FOUNDATION INVESTIGATION REPORT BY:
H. Q. Golder and Associates Limited -
Proposed Papineau Creek Crossing,
Highway No. 127 - Line 'S', Bayneoth, Ont.
N.P. 66-64, District 10 (Banerft).

RE: SOIL CONDITIONS AND FOUNDATIONS,
PROPOSED PAPINEAU CREEK CROSSING,
W.P. 66-64,
MAYNOOTH, ONTARIO.

Proposed Papineau Creek Crossing --
Hwy. #127 - Line 'S', Maynooth, Ont.,
W.P. 66-64 - District #10 (Bancroft).

RE: W.P. 32-65, Papineau Creek, Site #11-5, Hwy. #127,
District #10, Bancroft.

ERECT STRUCTURE
BRIDGE DRAWINGS
D-6021 1 to 10

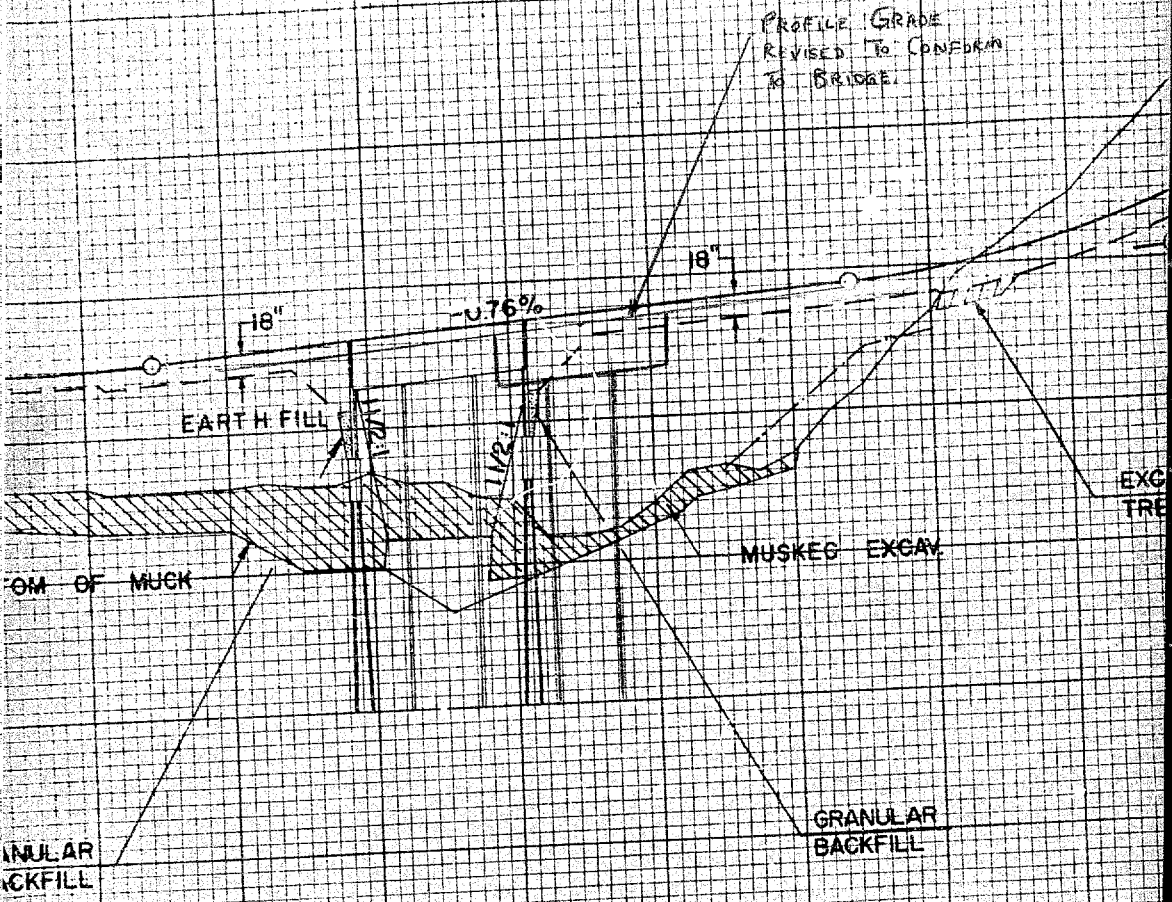
In the interests of economy and to avoid possible difficult work through the swamp area, it has been agreed to move the structure location 100 ft. southward along the proposed highway (to Station 30+50 for CL bridge channel) as shown in red on the attached sketch.

It should be noted that these revised stream diversion channels are minimal and they should be improved if found practicable.

It was also agreed that the profile grade would be adjusted to conform to the bridge elevations.

CONTRACT No.
DRAWING No.
D-6021-P1

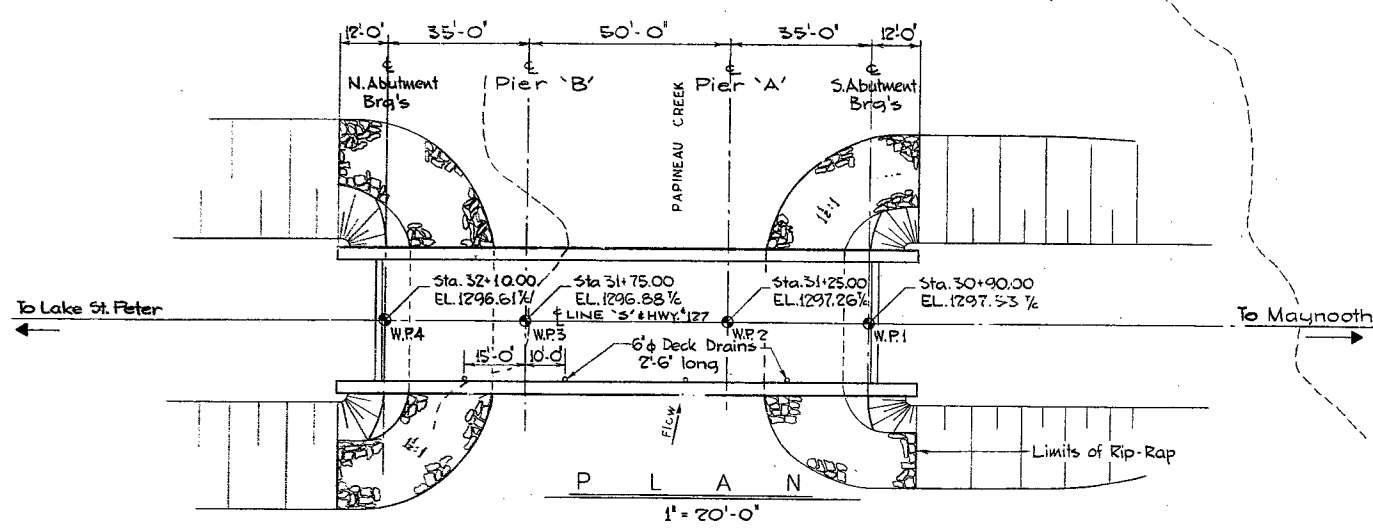
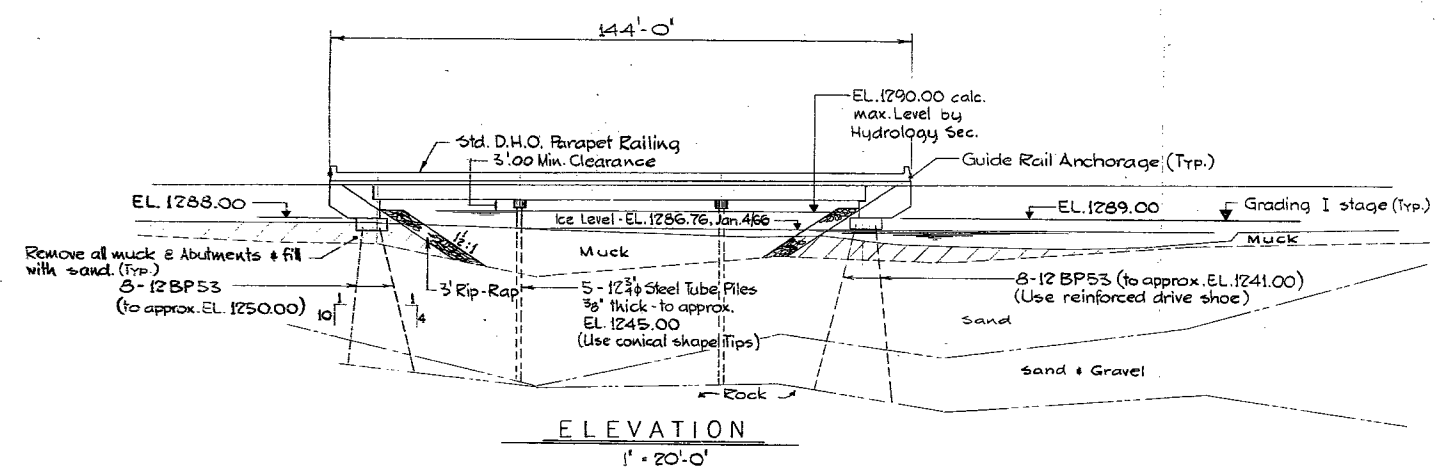
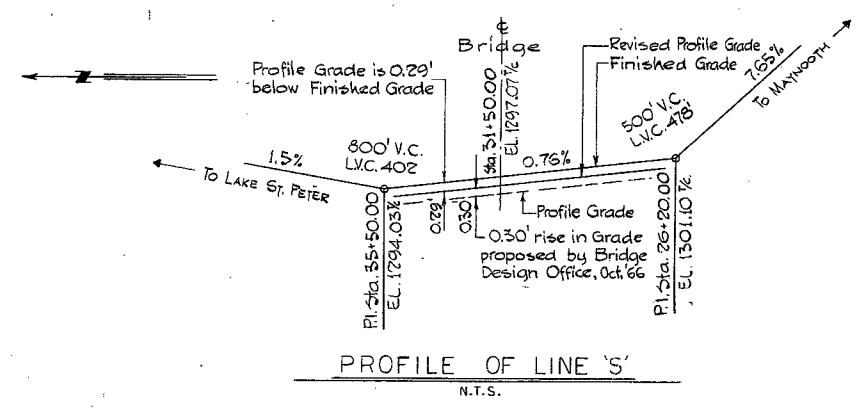
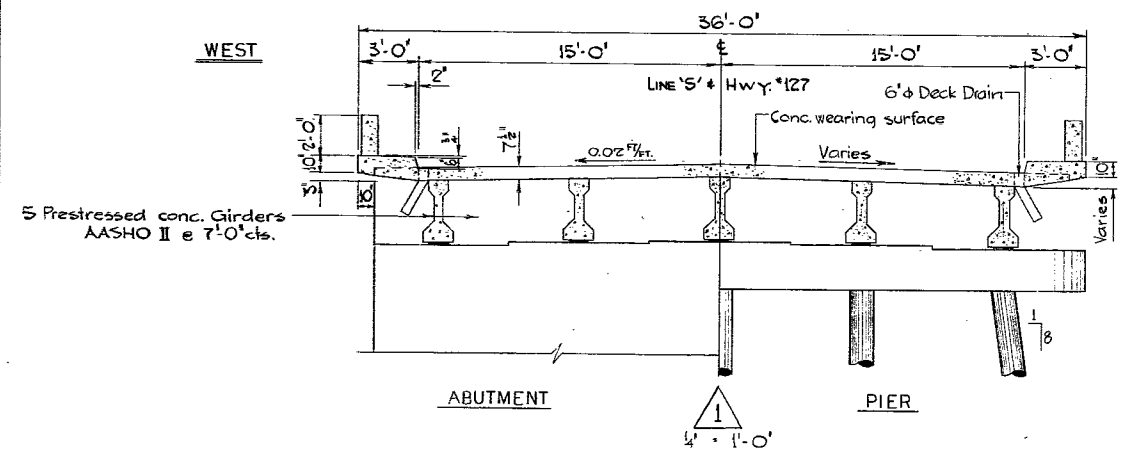
We have reviewed the Preliminary Plan #D-6021-P1
for the above mentioned structure.

It appears that the designer complied with the
recommendations contained in the foundation report
prepared by soil consultants, H. Q. Golder and Associates.

*← Report and also
their drawings indicate W.P. 66-64 - Why?*
